**SYDNEY METRO CITY & SOUTH WEST
 CONSTRUCTION TRAFFIC MANAGEMENT PLAN
 CHATSWOOD DIVE SITE**

MAY 2017

CTMP Review Comments Sheet

DRAWING No:	DD-SYDM-DWG-0001-06	
SHEET	1	OF 2
REVISION	C-01

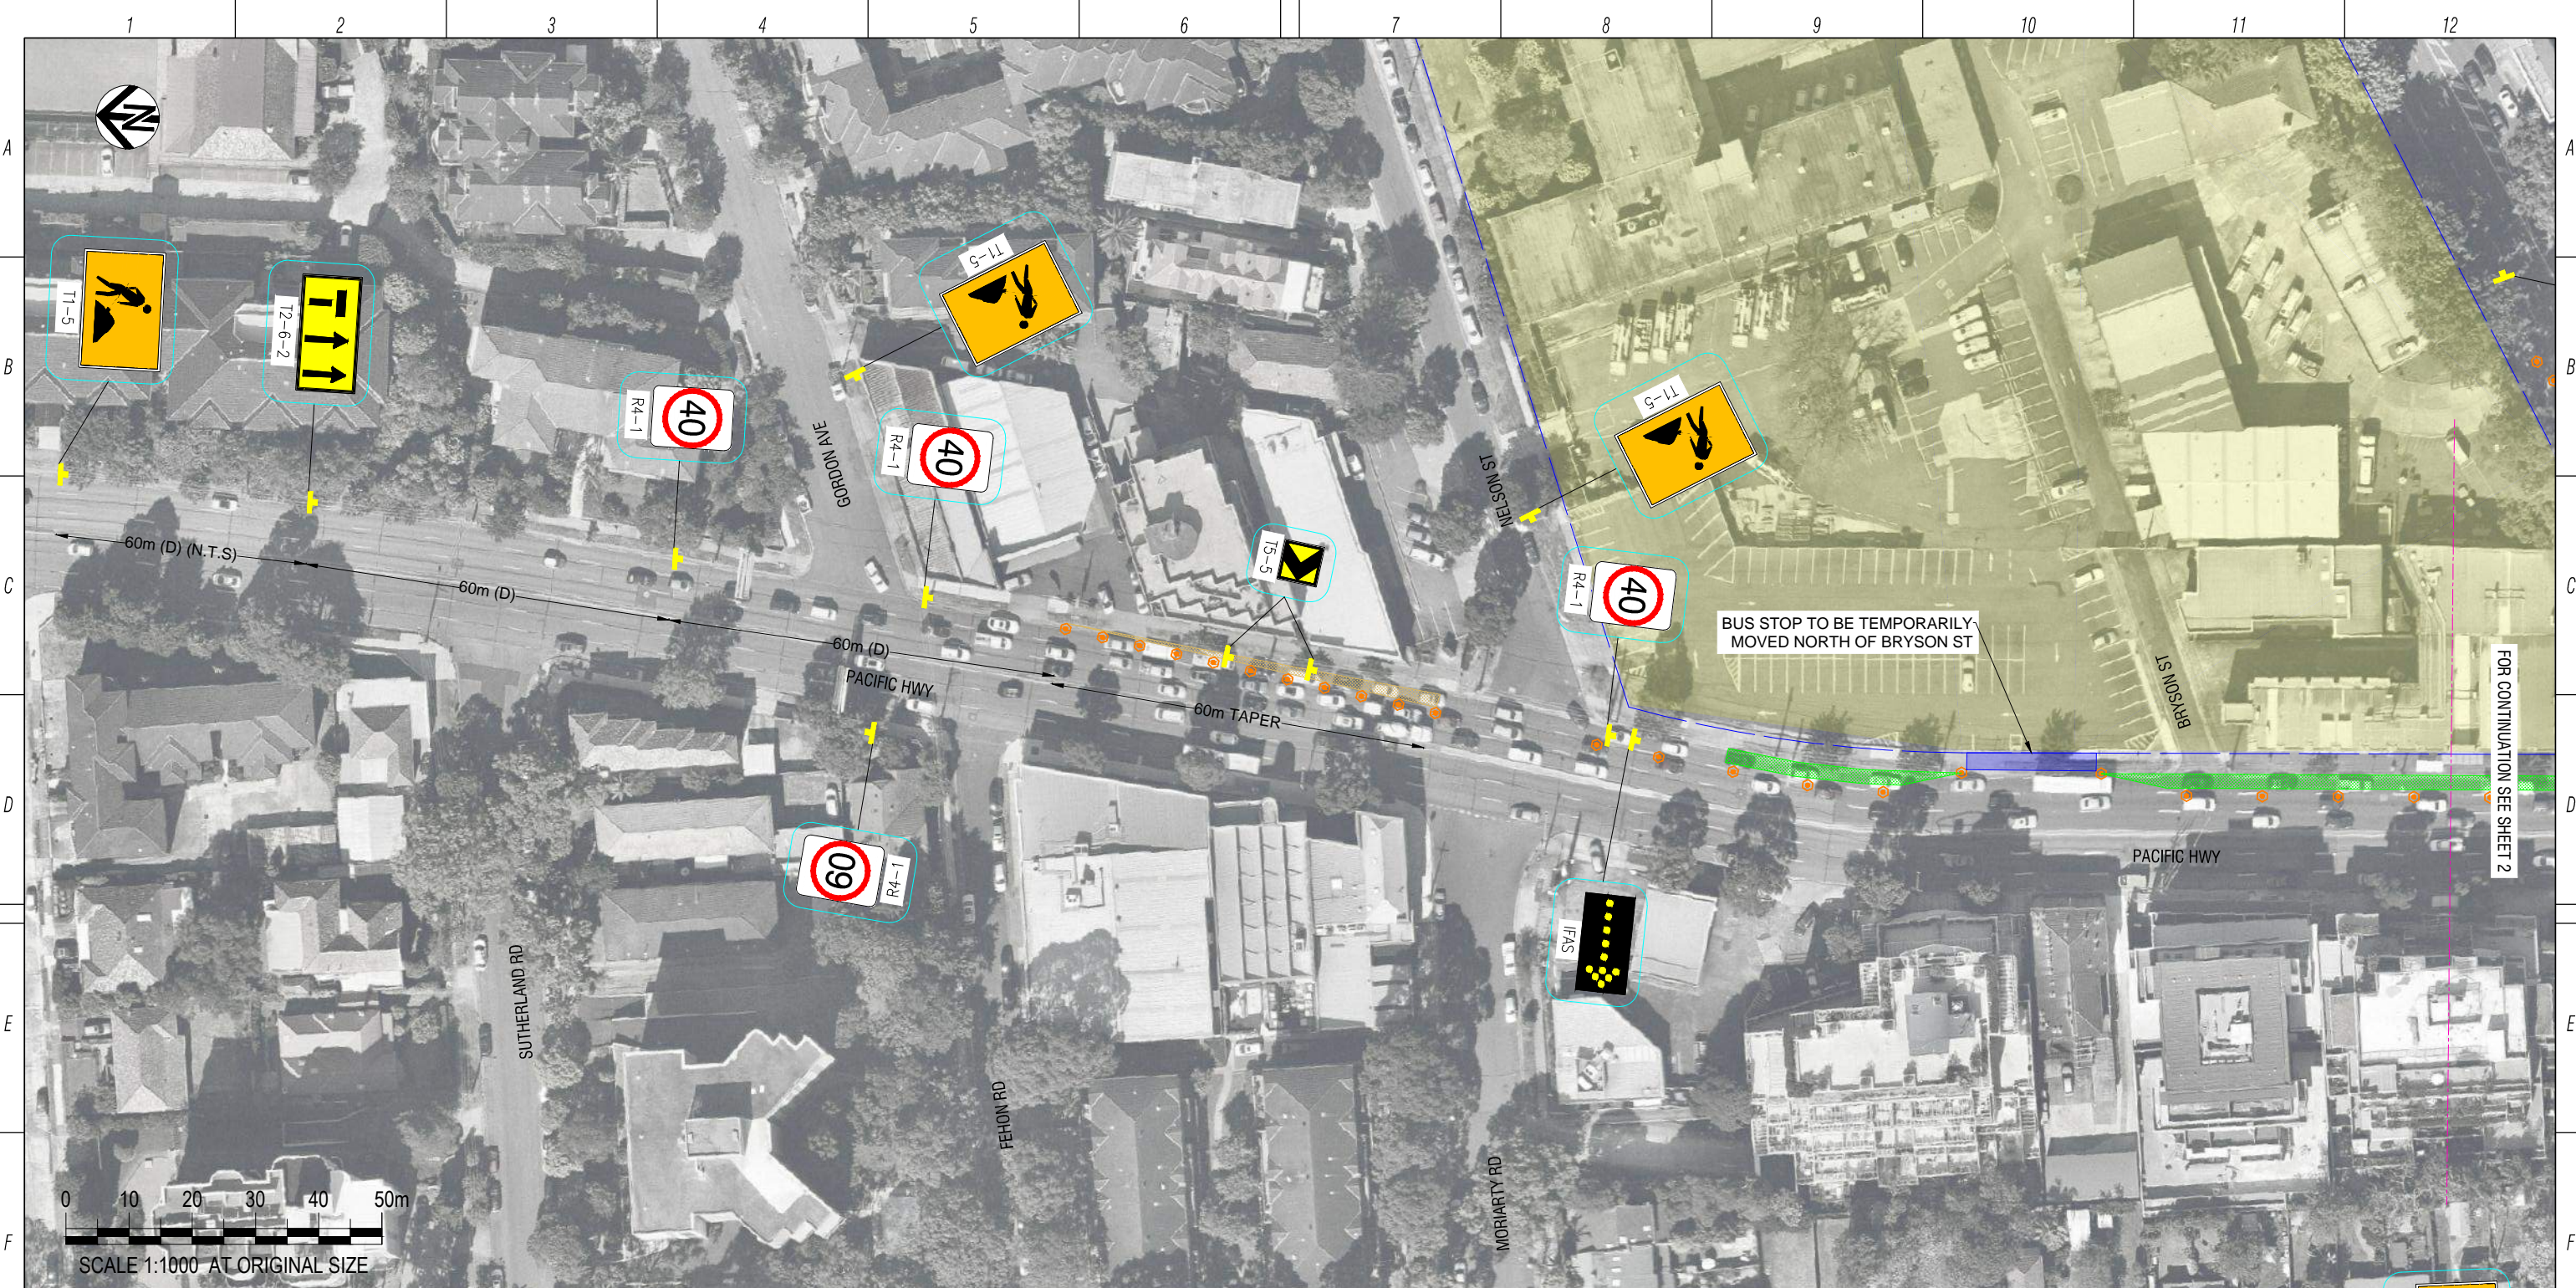
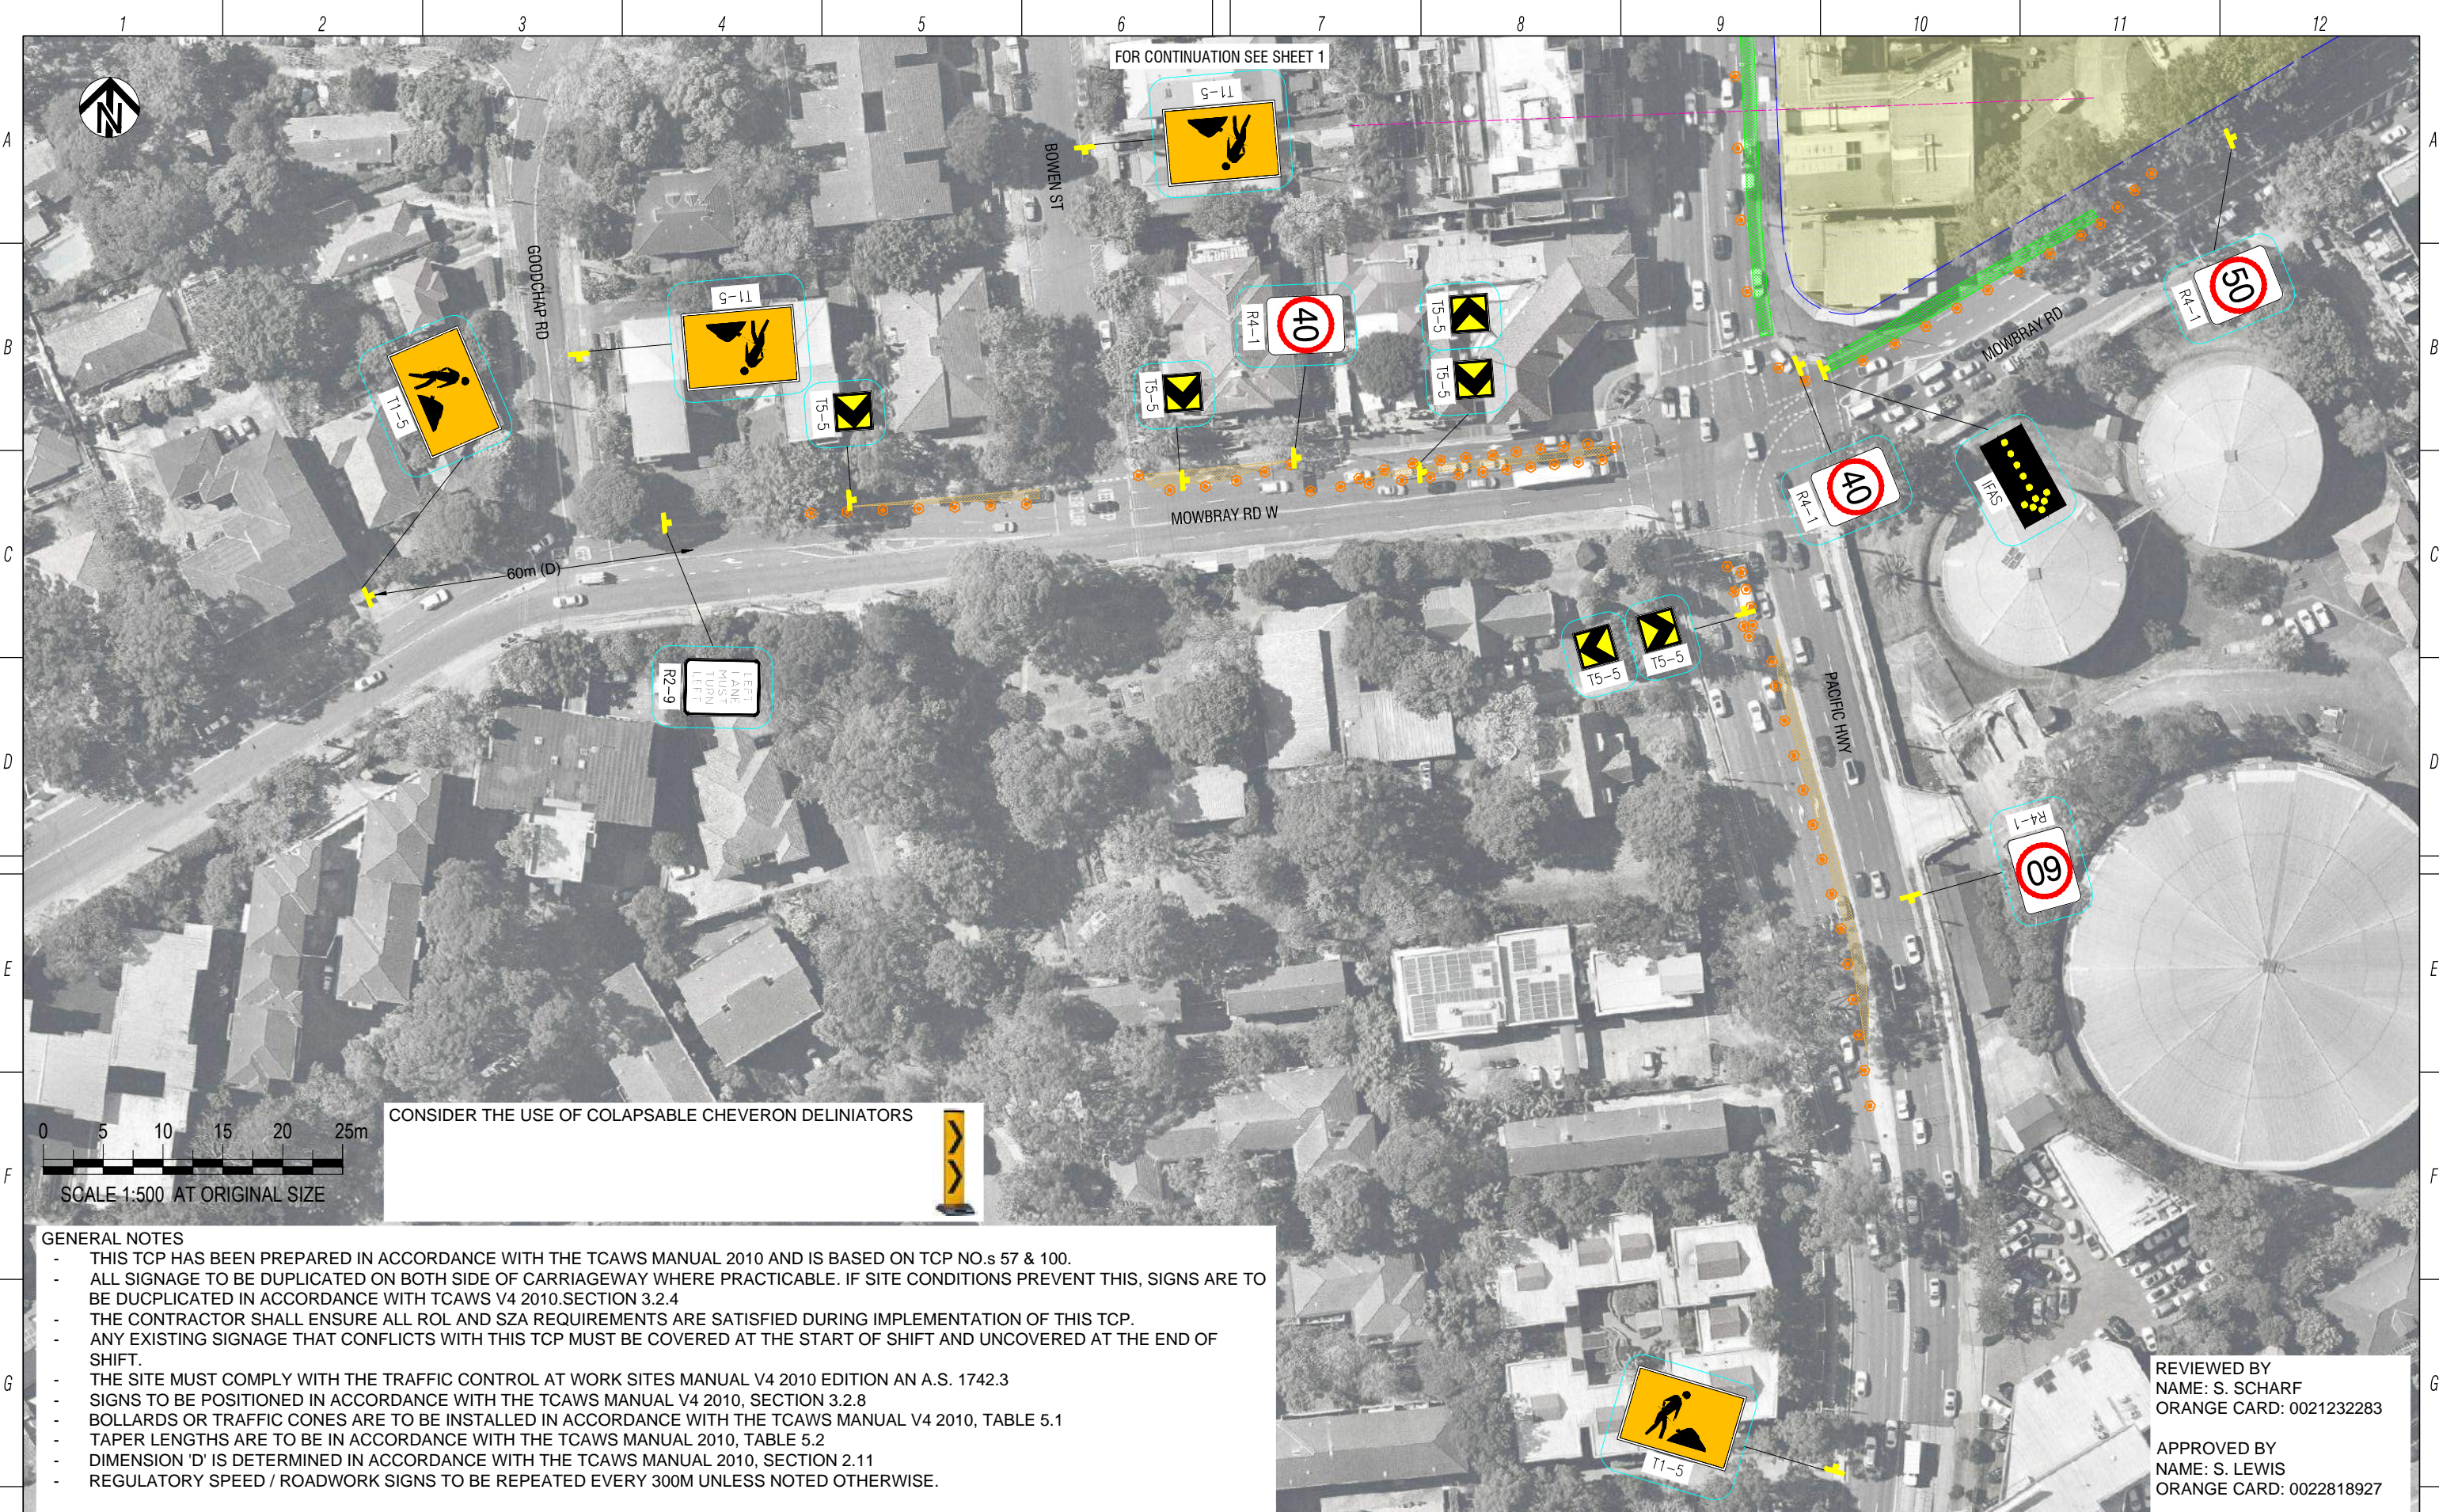
Item	Section/ Page	Comments	Response
1	Pages 22 and 26	What is the significance of the areas shown in bright green on page 22 and 26? What are the orange areas? What are the orange dots?	the bright green areas are: DWG-0001-6 Sheets 1 and 2- lane closure DWG-0001-07 - swept path orange dots are bollards
2	Page 24	On page 24 it is indicated that pedestrians must move to the right. Does that mean pedestrians should use the footpath on the other side of Pacific Highway? If so how will pedestrians be protected from traffic?	the pedestrians would be within the closed lane - if you would like the pedestrians detoured then please confirm
3	Appendix 5	Do you have the Road Safety Audit referred to in Appendix 5 (blank)	Included in current document
